RENESAS TECHNICAL UPDATE

Product Category	MPU&MCU	Document No.	TN-H8*-A400A/E	Rev.	1.00
Title	Correction of errors in the H8SX/1638 and H8SX/1638L Group Hardware Manual		Information Category	Technical Notification	
Applicable Product	H8SX/1638 and H8SX/1638L Group	Lot No.	Reference Document	H8SX/1638 Group , H8SX/1638L Group Hardware Manual (REJ09B0364-0200)	
		All lots

(1) Page 354, DTCER description in figure 11.1, Block Diagram of DTC

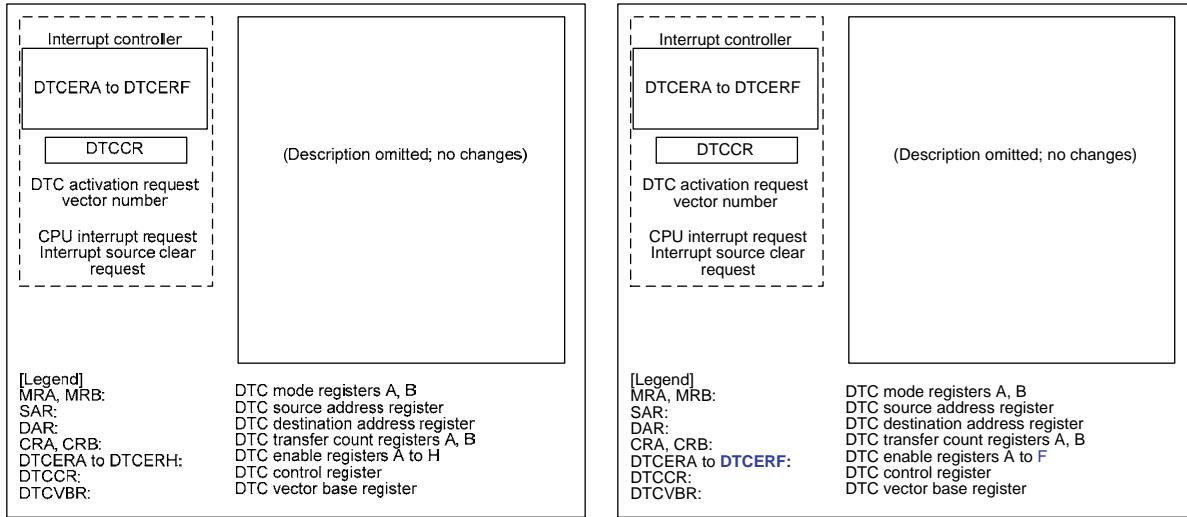
Deletion of DTCERG, and DTCERH in DTCER

[Before Change]

[After Change]
